### APPEAL SUMMARY

<b>Appeal ID:</b> 18791	<b>Project Address:</b> 3204 & 3202 SE Hawthorne Blvd
<b>Hearing Date:</b> 12/19/18	<b>Appellant Name:</b> Robert Halverson
<b>Case No.:</b> B-015	<b>Appellant Phone:</b> (971) 344-4565
<b>Appeal Type:</b> Building	<b>Plans Examiner/Inspector:</b> Kathy Aulwes
<b>Project Type:</b> commercial	<b>Stories:</b> 1 <b>Occupancy:</b> M <b>Construction Type:</b> III-B
<b>Building/Business Name:</b> Savvy Plus	<b>Fire Sprinklers:</b> No
<b>Appeal Involves:</b> Alteration of an existing structure	<b>LUR or Permit Application No.:</b> 18-262211-CO
<b>Plan Submitted Option:</b> pdf [File 1] [File 2]	<b>Proposed use:</b> Consignment Clothing Boutique

TENANT IMPROVEMENT FOR SAVVY PLUS - 3202 + 3204 SE HAWTHORNE BLVD.  
SCALE 1/8" = .75' DATE - 11/25/2018

SHEET C

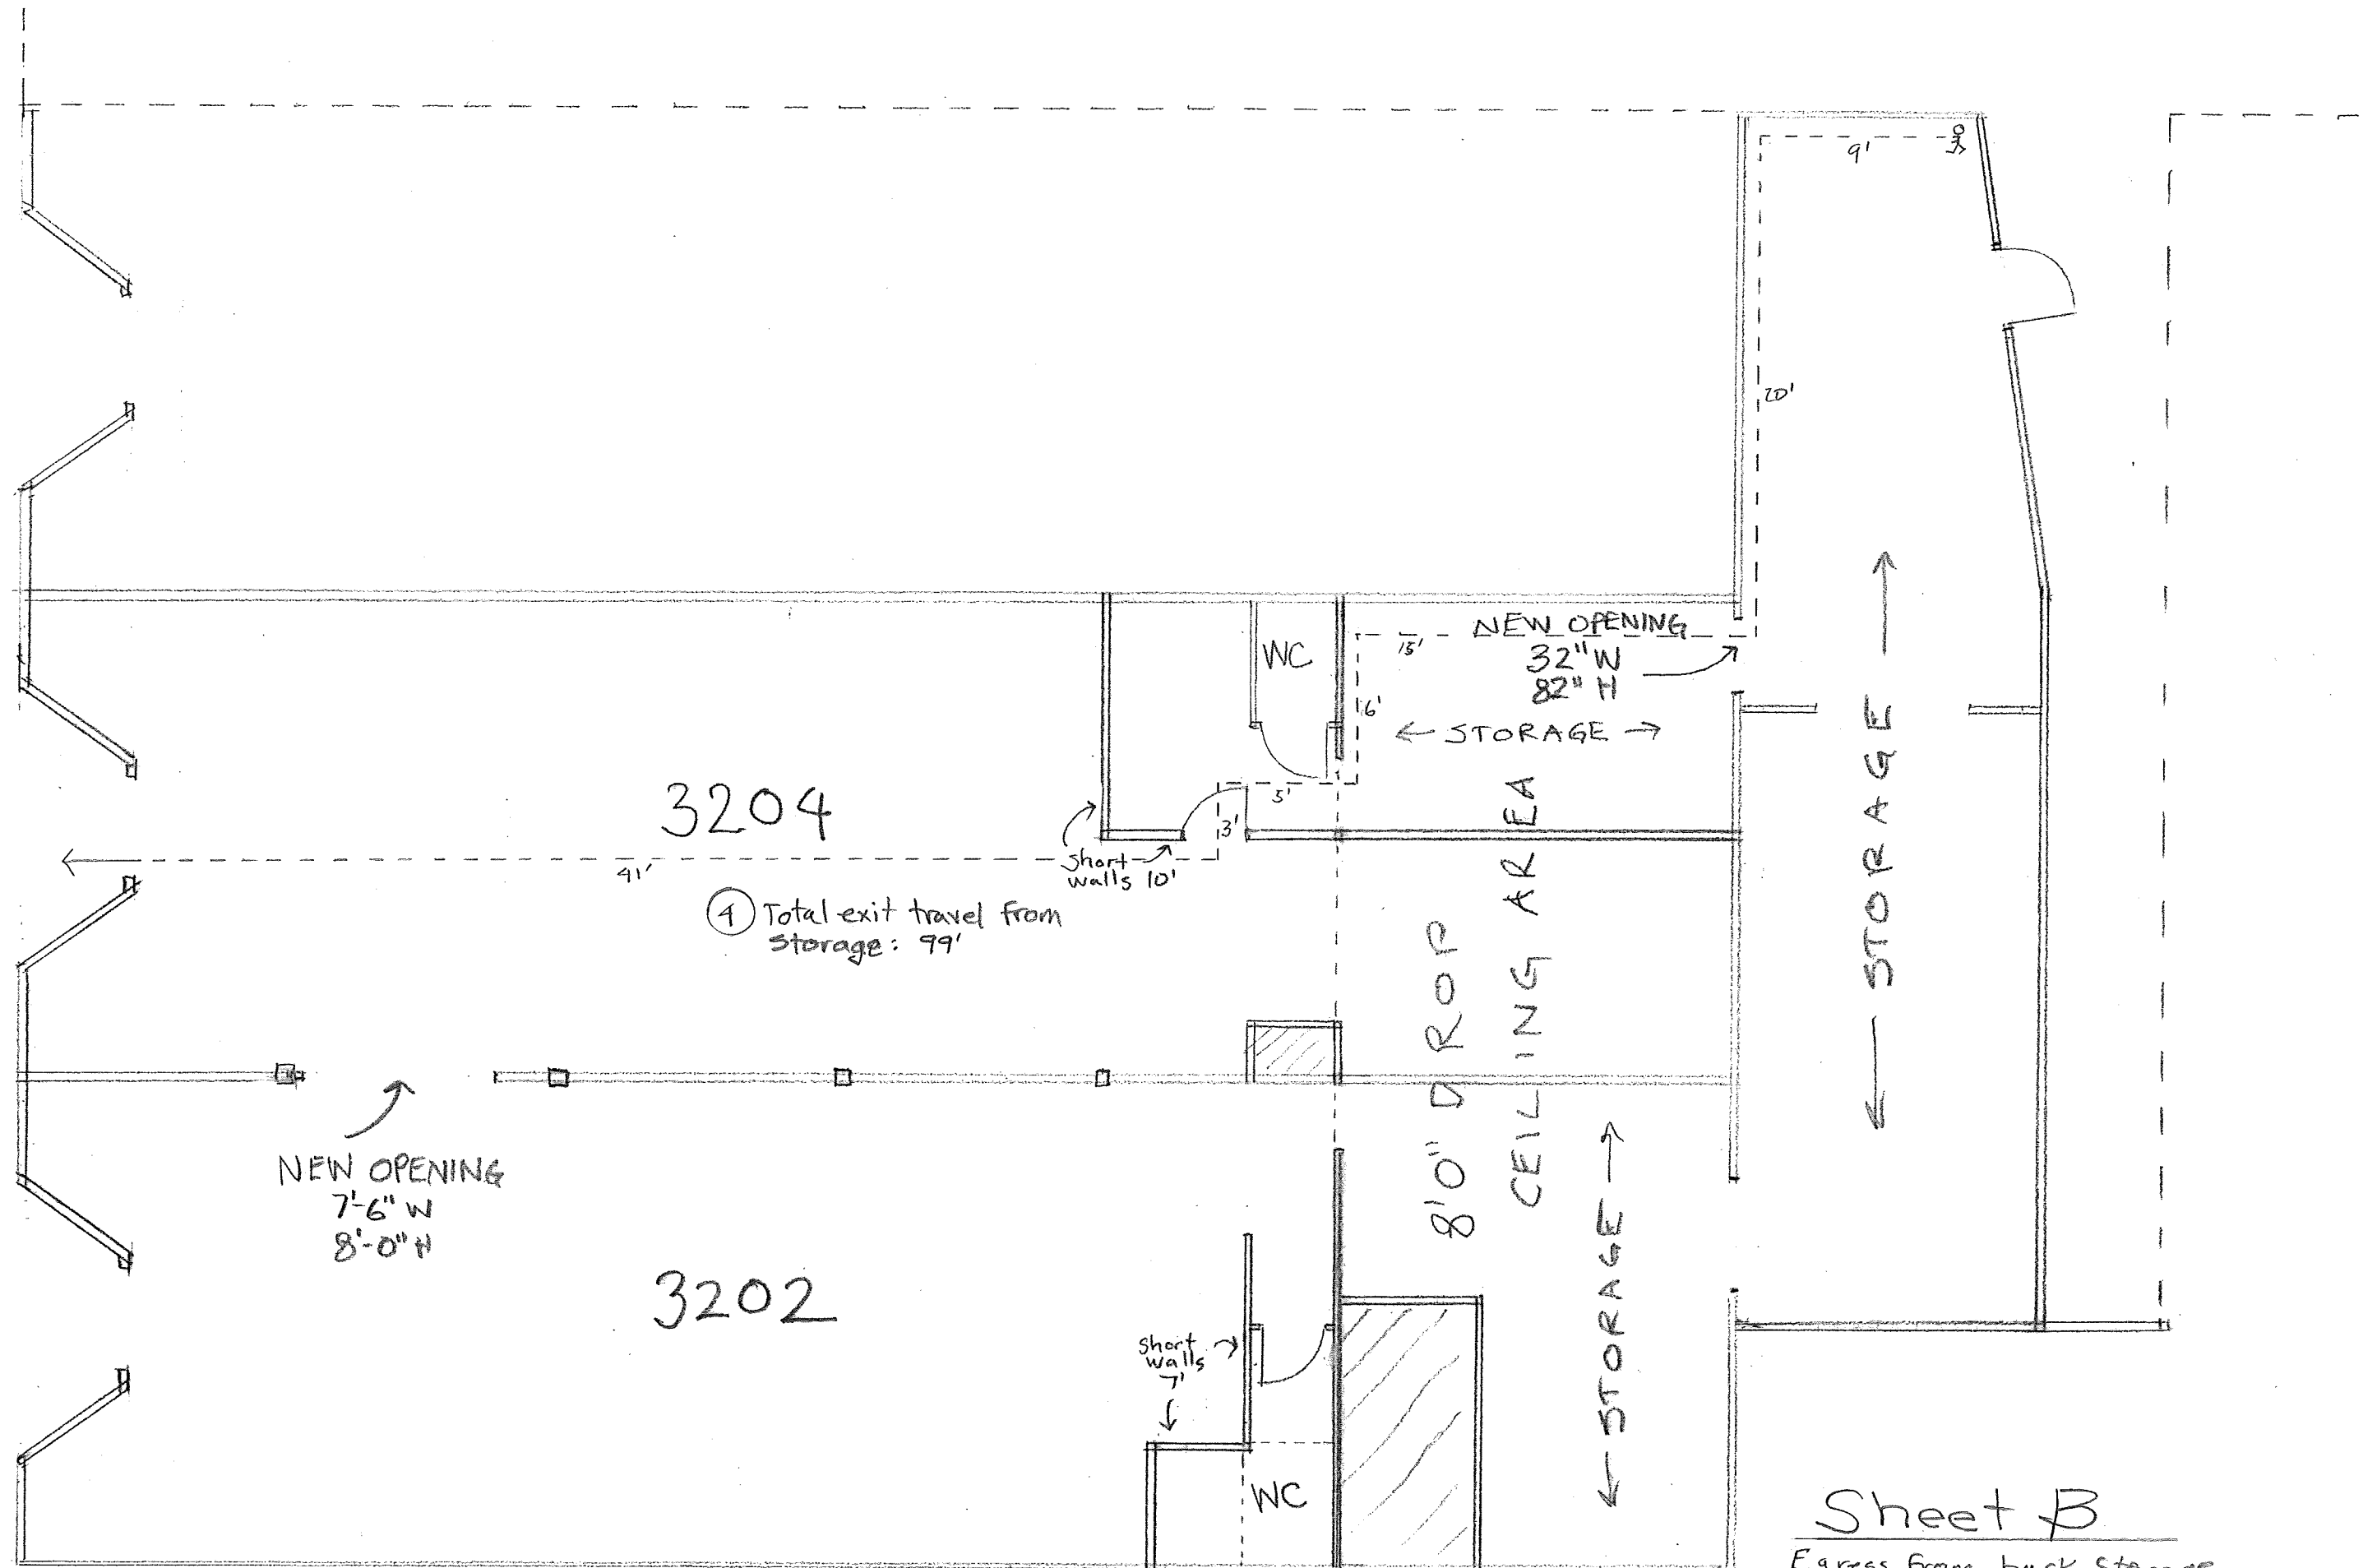
Propose adding an accessible electric door opener at the 3204 door, and a sign at the 3202 door indicating location of the accessible door at 3204. The pull side activation button will be placed to allow opening of the door without needing to enter an 18" clear area. There is no clearance problem on the push side – 12" clearance at the latch will be provided. Location of the activation buttons will comply with ICC A117.1 ANSI 404.3.5 and 309. The activation buttons will be placed and beyond the arc of the door swing, 36" above the sidewalk or floor, providing an unobstructed forward reach for activation. They will be operable with one hand without tight grasping, pinching, or twisting of the wrist. The force required to activate the opener button will less than 5.0 pounds. See Sheet C Entry Detail.

**Reason for alternative** Because doors are inset, changing the doors to out-swinging results in an impediment to the accessibility minimum pull side clearance of 18" at the latch side. Providing this 18" clearance cannot be achieved without major reconfiguration of the entrance.

The accessible electric door opener mitigates the need for 18" of maneuvering space at the latch side on the pull side of the door by allowing the door to be opened by an activation button located with ample accessibility clearance.

**Omission of 18 inch clear space on latch side of existing door with automatic door opener: Granted as proposed.**

Sheet B  
Egress from back Storage

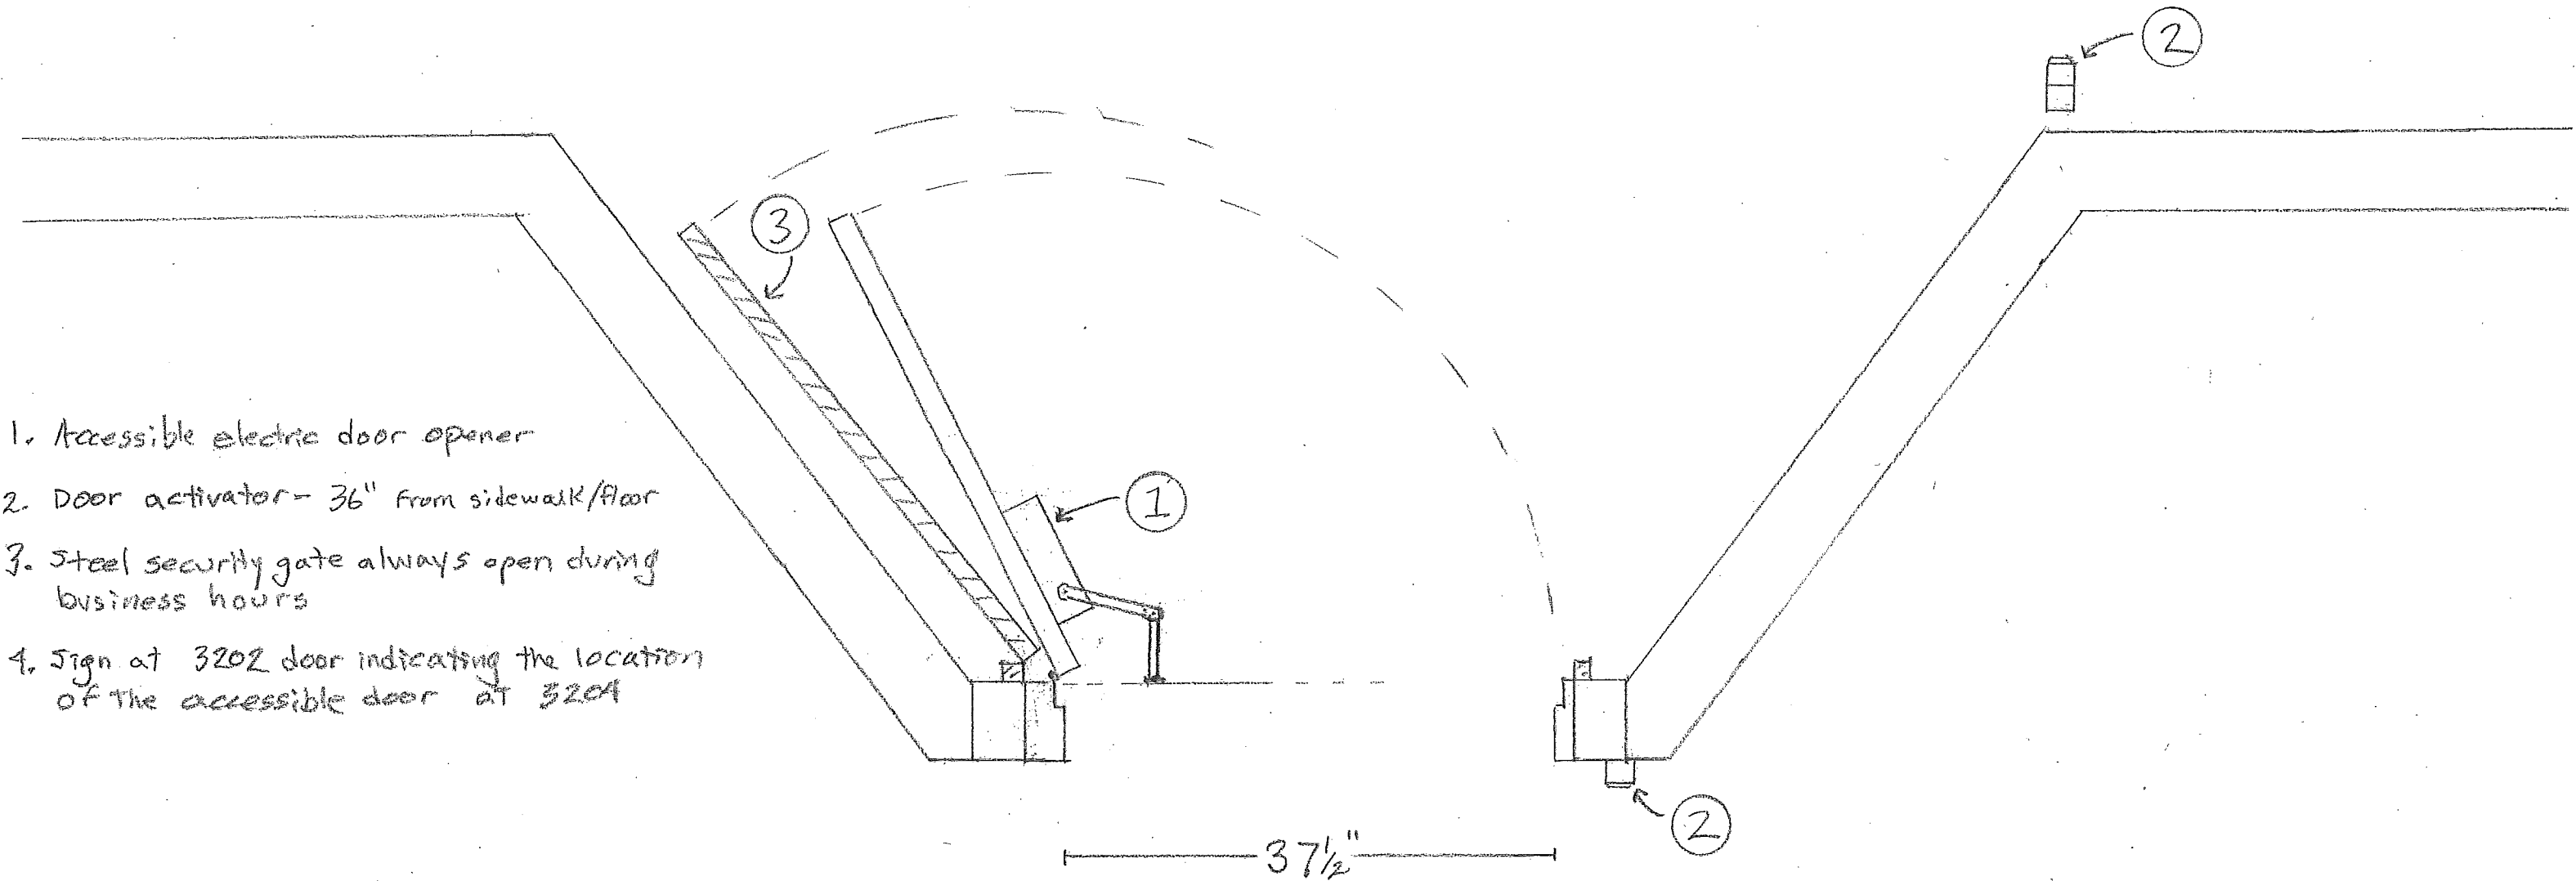
**Proposed Design** Changing front entry doors to open out is required for life safety – per check sheet 3b:

"The exit door must swing out in the direction of egress if the combined occupant loads from both spaces exceeds 49."
